FORT KNOX MINE

RECLAMATION AND CLOSURE PLAN

AMENDMENT 1

REVISION 1

Figure 3-1: Victoria Creek WRD Post Reclamation Topography

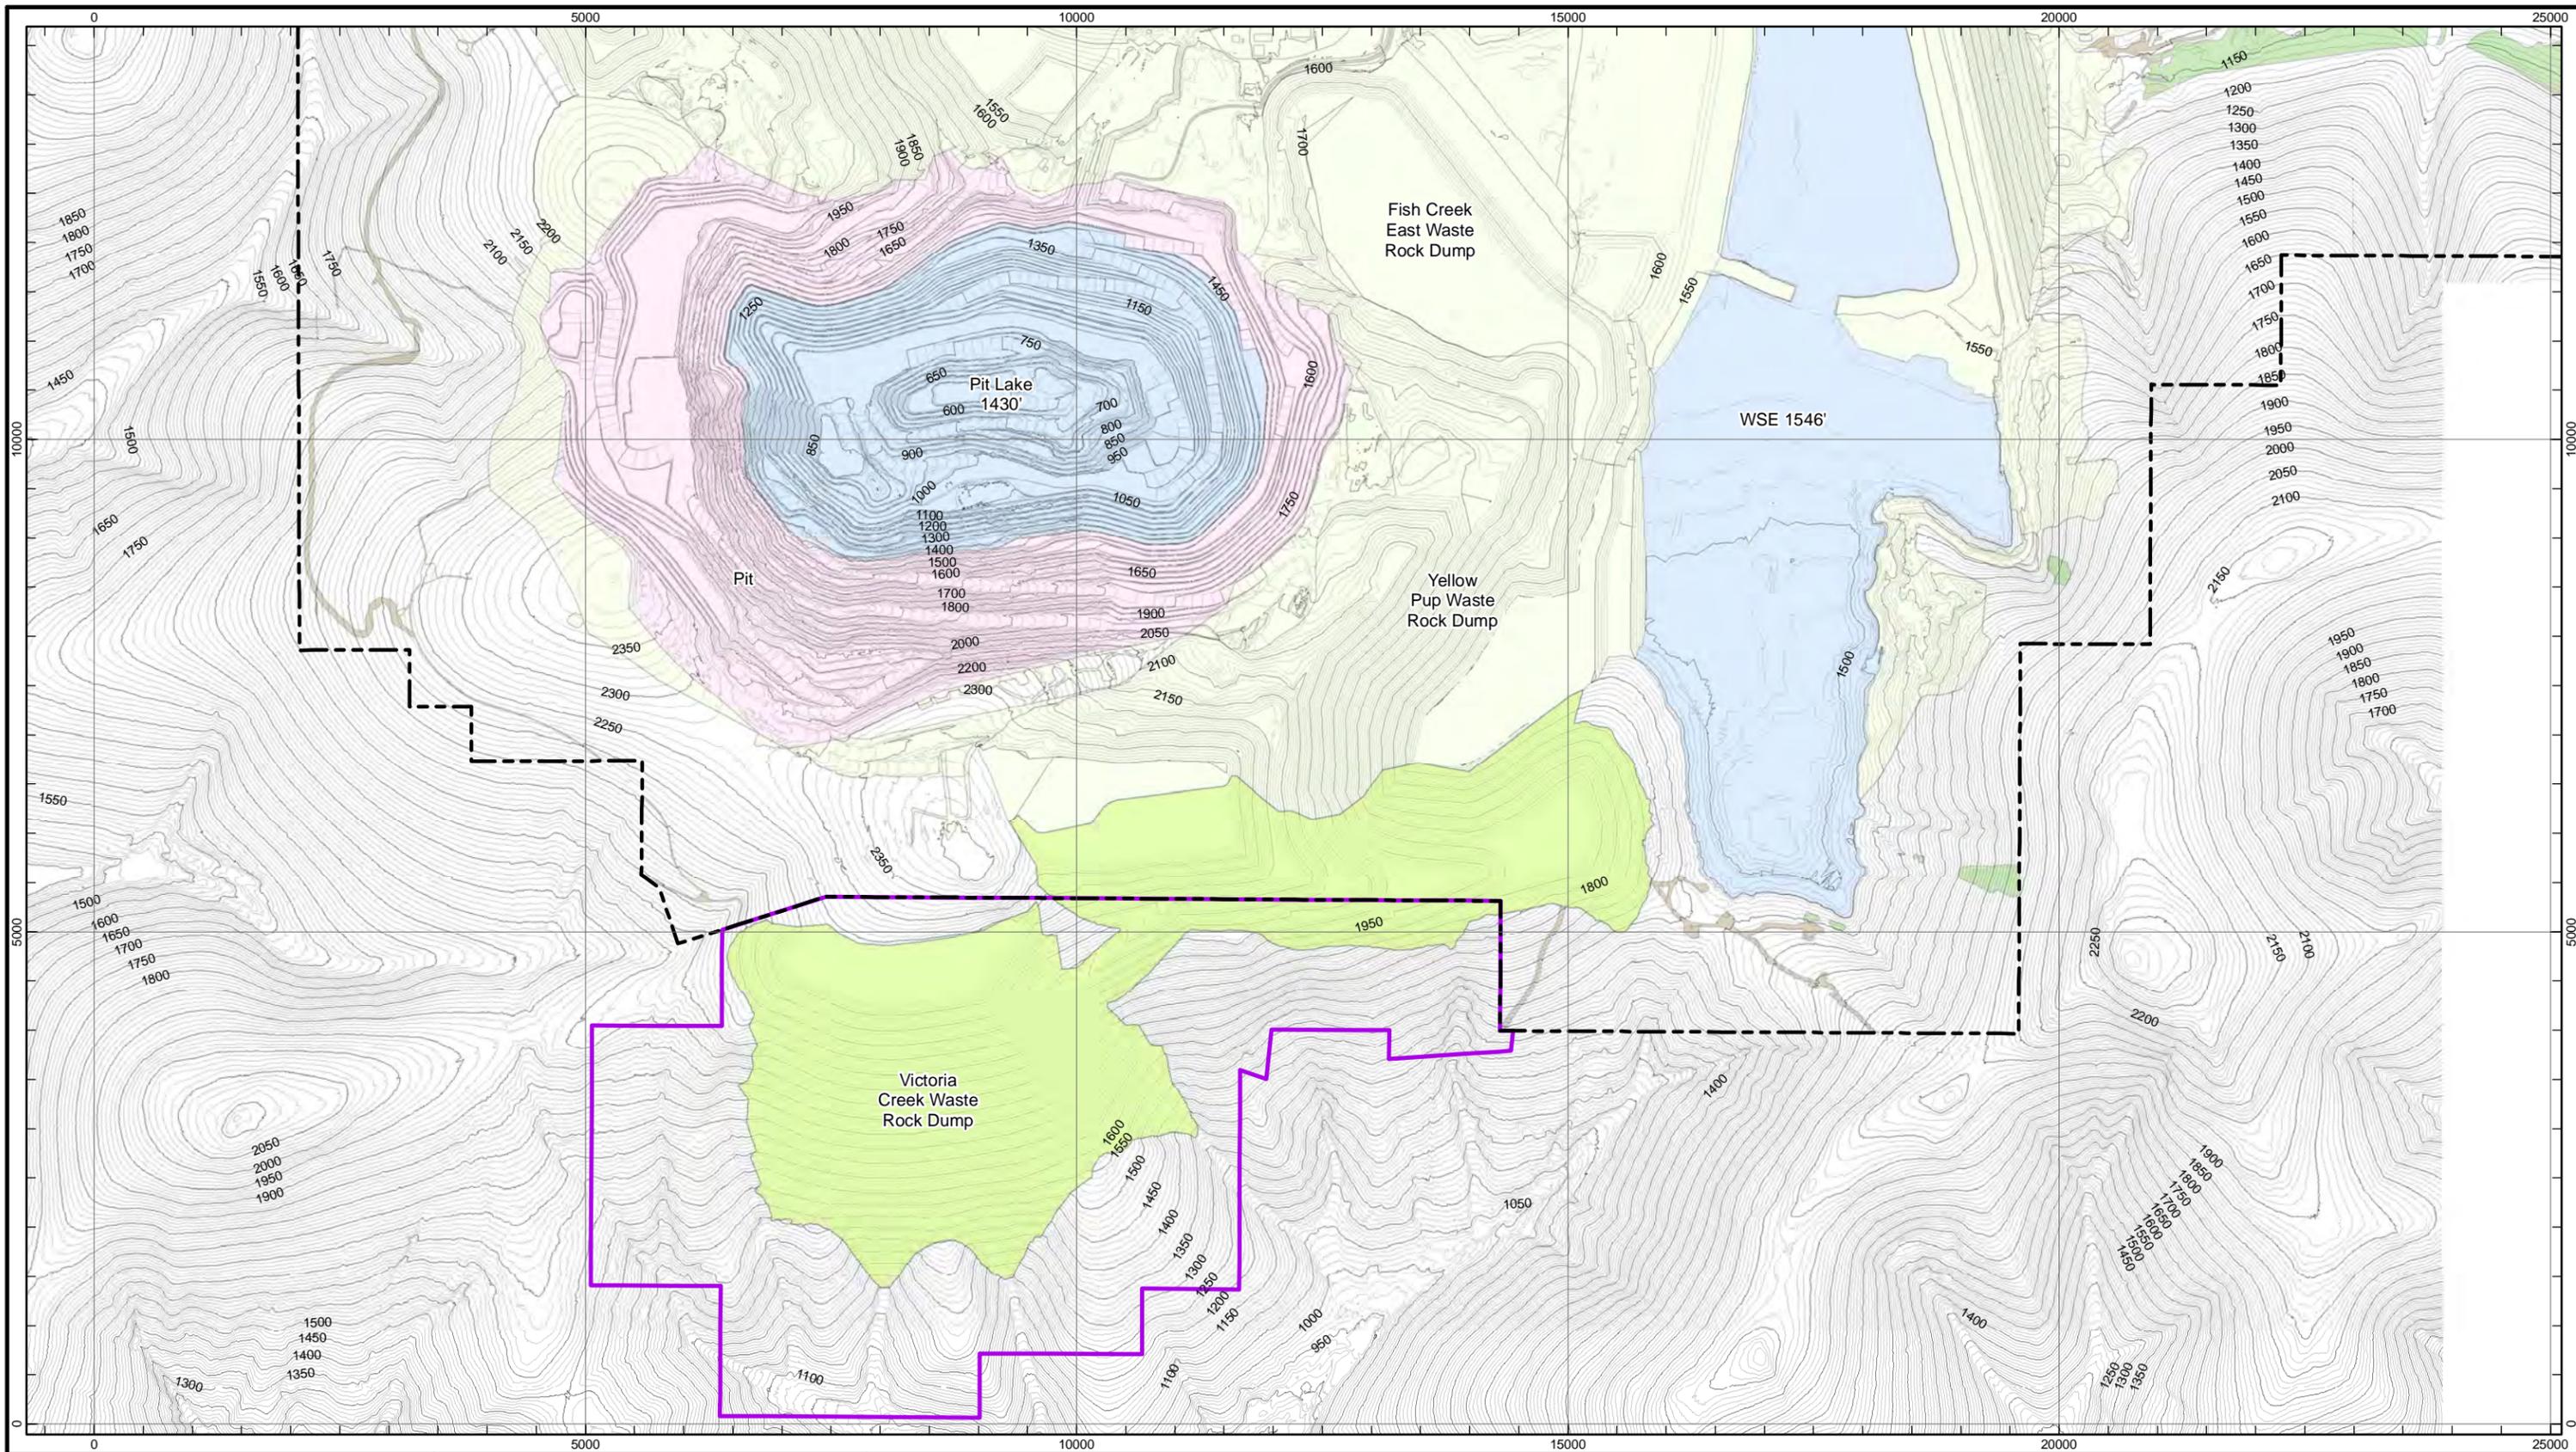
The Victoria Creek WRD will be graded, contoured and revegetated. A minimum of one foot of growth media will be applied to the graded and contoured slopes; slopes will be scarified and seeded. Generally, slopes will be graded to a maximum slope of 2.5H:1V or flatter. The design as presented in **Figure 3-1** includes contoured slopes between 2.5H:1V and 3H:1V.

Figure 3-2: Victoria Creek WRD Closure Drainage Plan

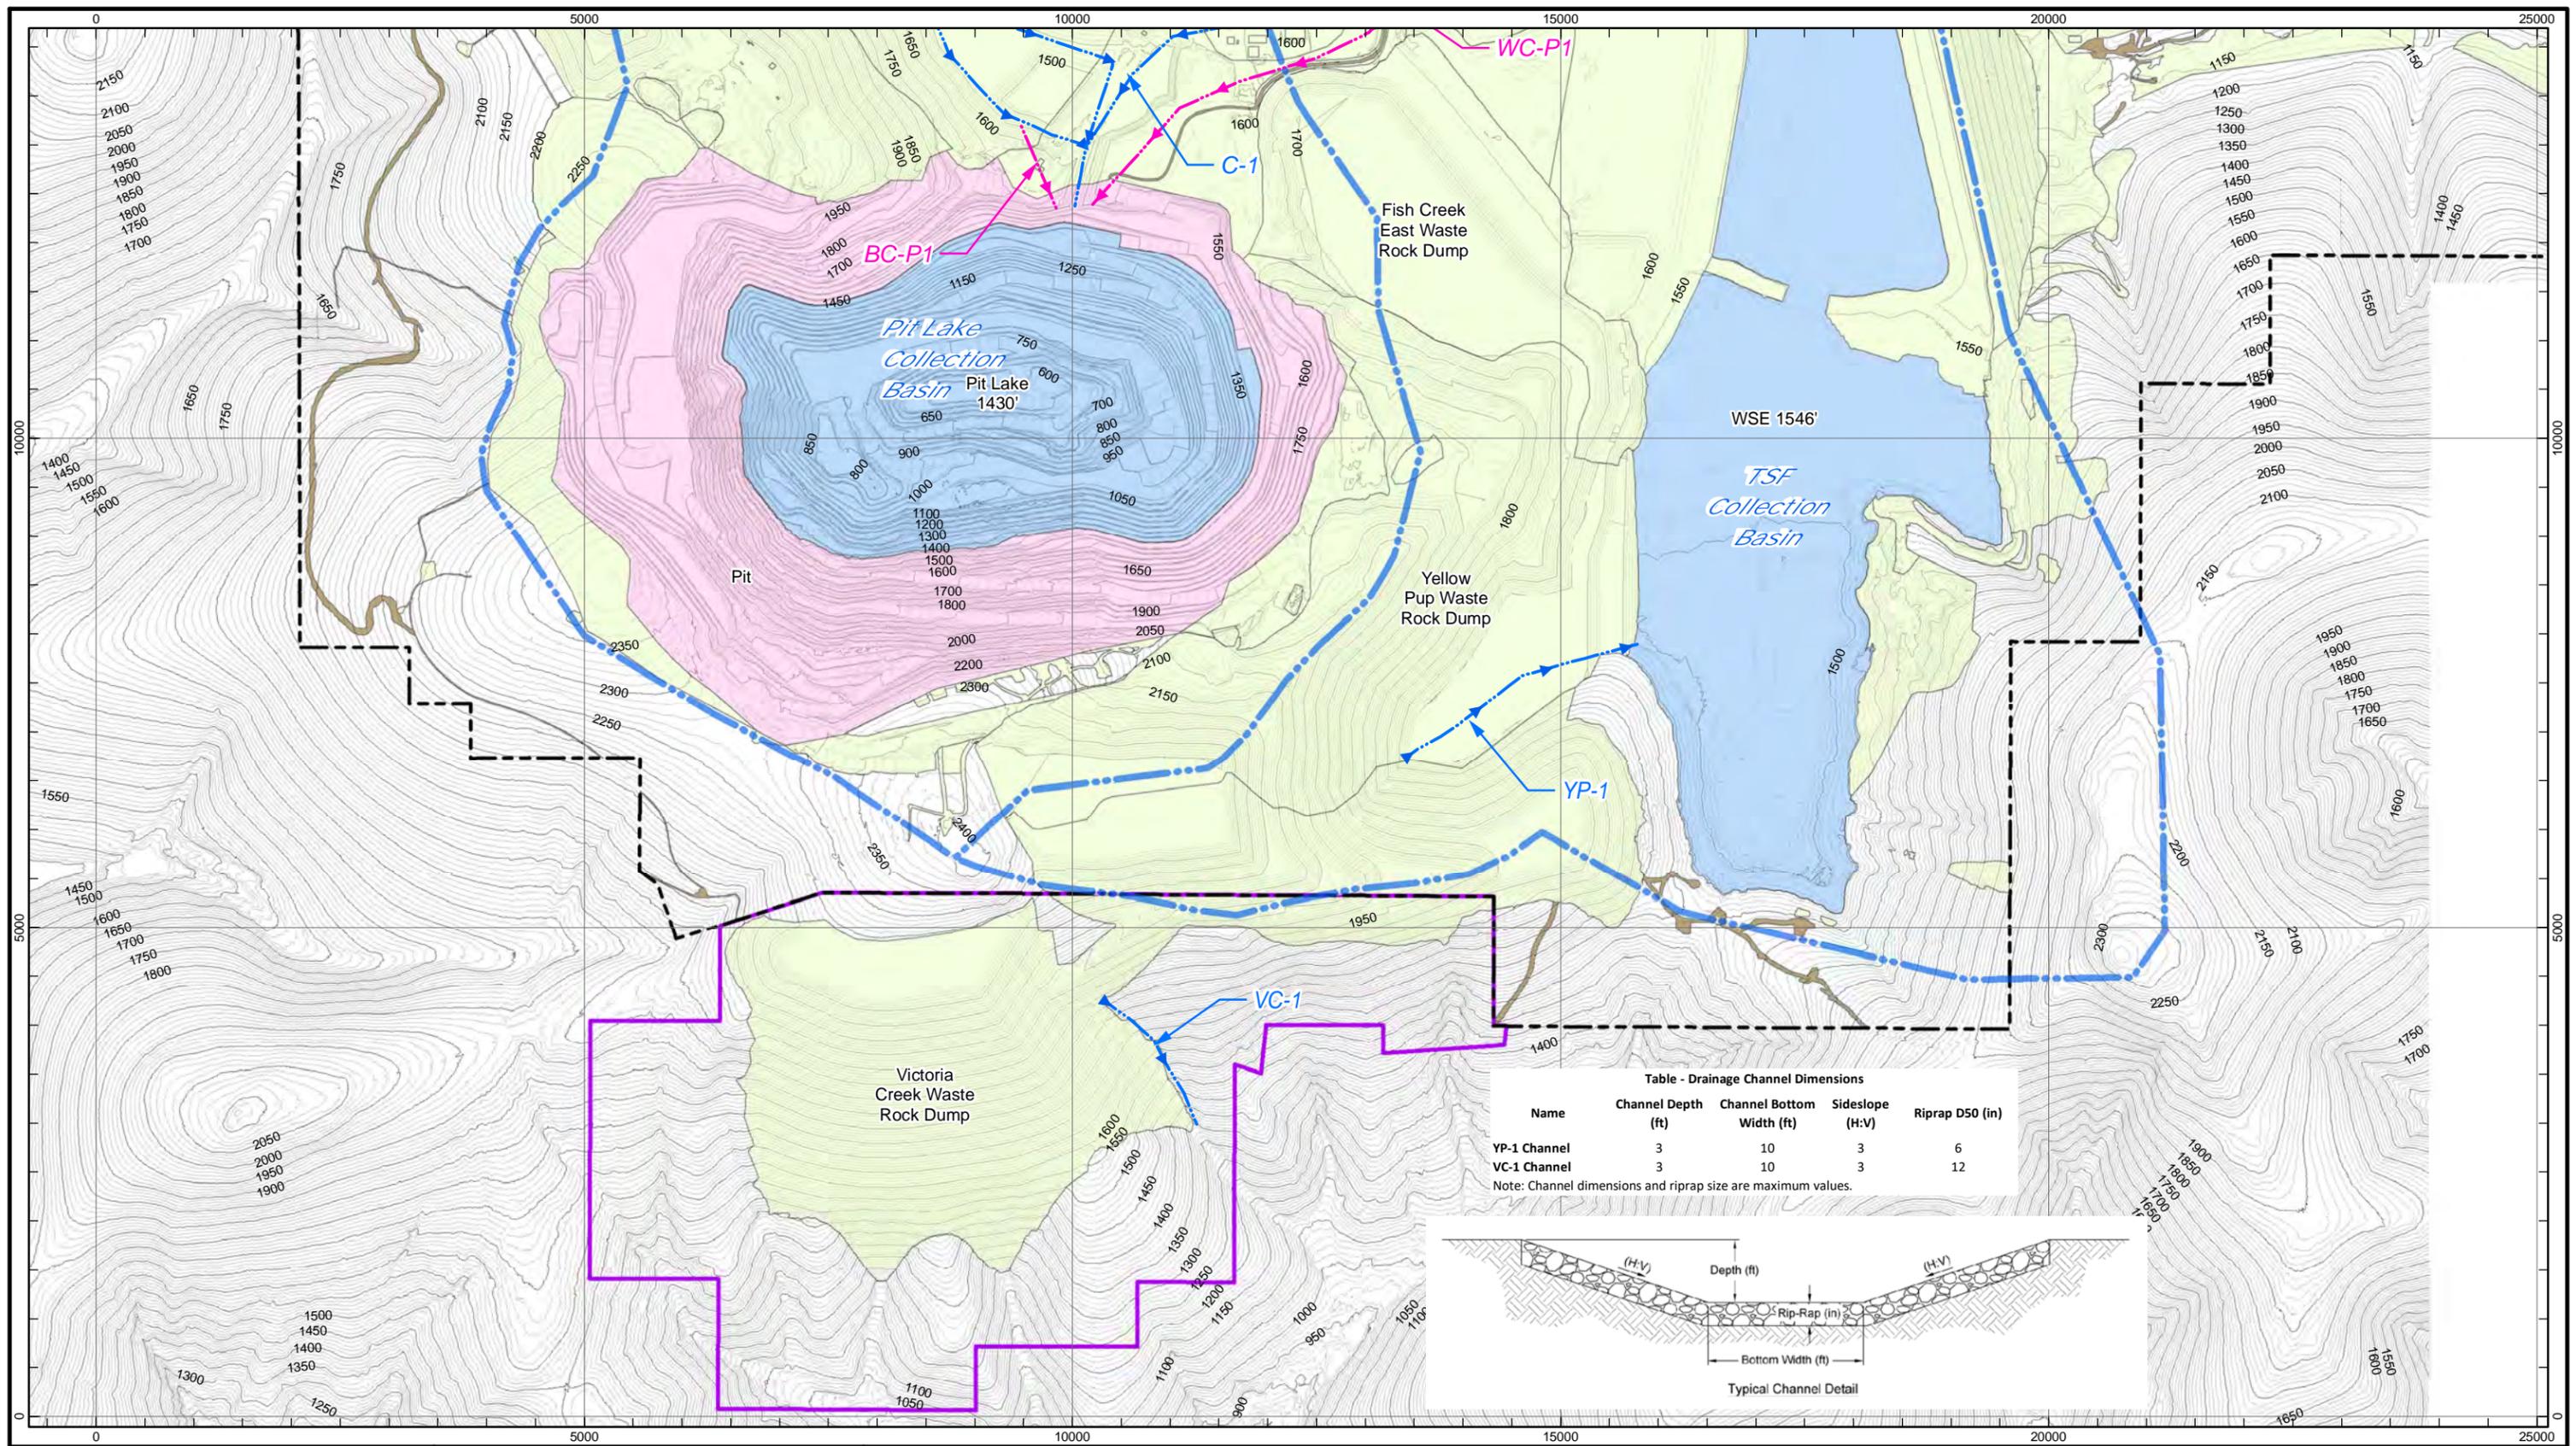
The overall site drainage plan remains unchanged. All impacted water will report to the Pit or TSF prior to treatment and release. The runoff from the Victoria Creek WRD is not expected to impact water quality or deviate from previous assumptions of runoff from waste rock included in the 2020 Reclamation Plan. A portion of the proposed Victoria Creek WRD will drain into the Victoria creek watershed (a recent placer mining area).

Best management practices (BMPs) will be employed during operations and until the site is reclaimed and stabilized to minimize erosion and sediment accumulation downstream. BMPs may include vegetated buffers, sediment collection ponds, or methods to reduce erosion potential during operations such as temporary grading or seeding. The current closure concept includes installation of a riprap lined swale along the eastern groin of the final graded surface of the Victoria Creek WRD within Victoria Creek watershed. Runoff generated and collected along this channel is expected to be minor, and erosion potential is expected to be low once vegetation has been reestablished. The majority of the WRD will be graded to minimize concentration of runoff and shed water across a large face, reducing concentration of runoff and thus erosion potential. **Figure 3-2** represents an updated drainage plan for the site.
